**Planning Department
Transportation Development Services**

**Re: Lamar Albuquerque
1600 Airtech Court
Traffic Circulation Layout
Engineer's/Architect's Stamp dated 7-15-15 (M16-D024J1)**

Based upon the information provided in your resubmittal received 7-14-15, the above referenced plan cannot be approved for Building Permit until the following comments are addressed:

A1.04

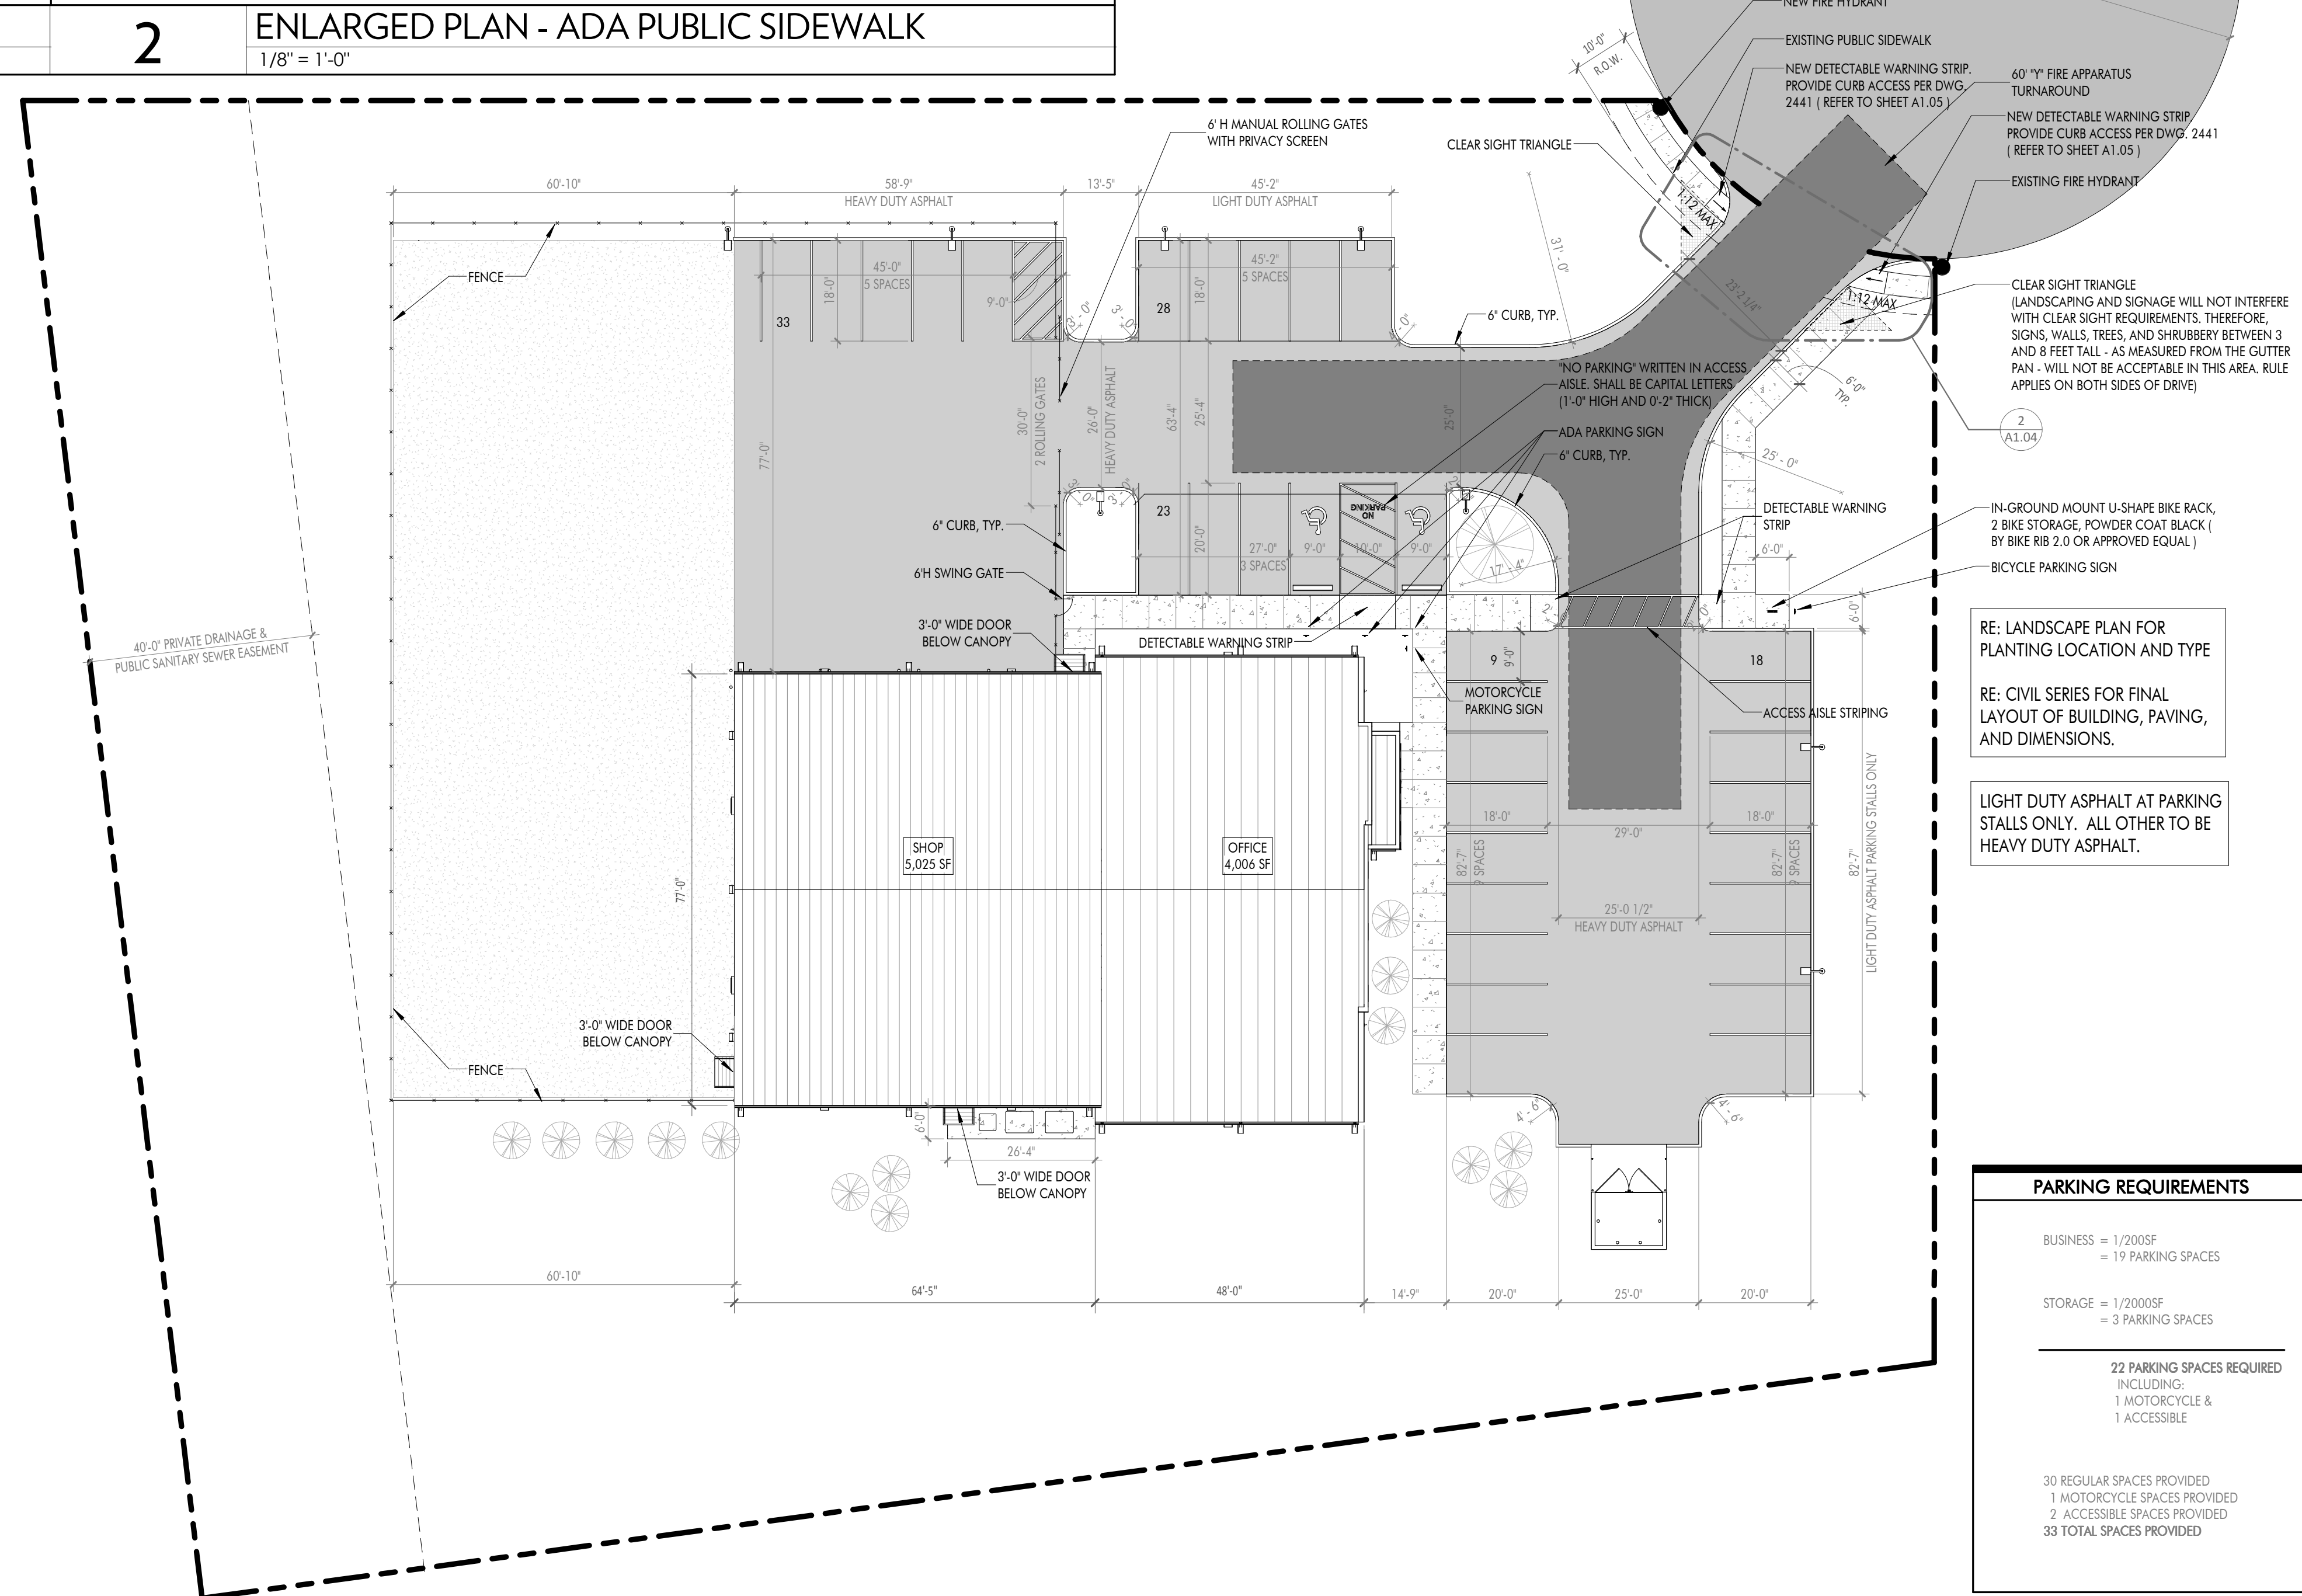
1. Please show a vicinity map showing the location of the development in relation to streets and well known landmarks. Please show a directional arrow.
2. Please show the extent of the project site. Please show the property line, fencing and any other development on the south side of the proposed project site.
3. Per ADA requirements ANSI 502.5, ADA parking spaces must have and unobstructed 8ft. wide by 18 ft. in length. Upon review of the submitted drawings, the wheel stops will be obstructing the total length of the ADA parking spaces.
4. Per DPM, the site must provide bicycle parking space and signage. Per COA Zoning requirements, there must be one bicycle space provided for every twenty automobile or light truck spaces. Please detail location of bicycle parking drawing.
5. Please include two copies of the traffic circulation layout at the next submittal.
